Access Compliance Report Public Rights-of-Way (Curb Ramps)

Main Street: RANDALL_ST Cross Street: RANDALL_ST Location: SE

ADA ID: RPRK211222130524 Ramp Type: Type 4 - Parallel Initial Pass/Fail: Fail Overall Compliance: No Severity Score: 2

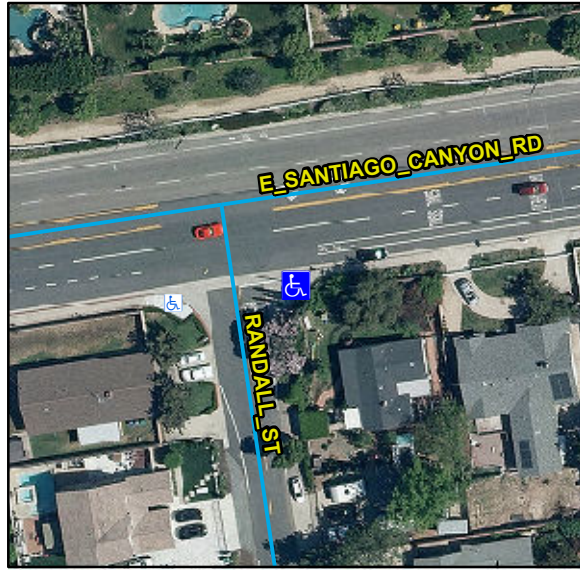
Compliance	Description	Data	Compliance	Description	Data
N/A	Ramp Length LT (in)	76	N/A	Ramp Length RT (in)	84
Yes	Ramp Width LT (in)	86	Yes	Ramp Width RT (in)	87
Yes	Ramp Run Slope LT (%)	6.4	Yes	Ramp Run Slope RT (%)	5.4
No	Ramp Cross Slope LT (%)	2.4	Yes	Ramp Cross Slope RT (%)	2
N/A	Landing Present	N/A	N/A	DWS Provided	N/A
N/A	Landing Length (in)	N/A	N/A	DWS Contrast	N/A
N/A	Landing Width (in)	N/A	N/A	DWS Length (in)	N/A
N/A	Landing Run Slope (%)	N/A	N/A	DWS Full Width	N/A
N/A	Landing Cross Slope (%)	N/A		DWS Offset Type	N/A
N/A	Landing Movement Obstructed?	N/A	N/A	DWS Offset Left (in)	N/A
	Landing Movement Type	N/A	N/A	DWS Offset Right (in)	N/A
N/A	Landing Shared	N/A			
N/A	Clear Space	Yes			
N/A	Clear Space To Crosswalk (in)	N/A			
N/A	Marked Crosswalk 1	No	N/A	Marked Crosswalk 2	No
	Crossing 1 Direction	N		Crossing 2 Direction	W
	Marked Crosswalk 1 Width (in)	N/A		Marked Crosswalk 2 Width (in)	N/A
N/A	Ramp Inside Crosswalk 1	N/A	N/A	Ramp Inside Crosswalk 2	N/A

Remove & Replace Curb Ramp With Two New Directional Ramps or Equivalent.

R304.5.3, STD 1115
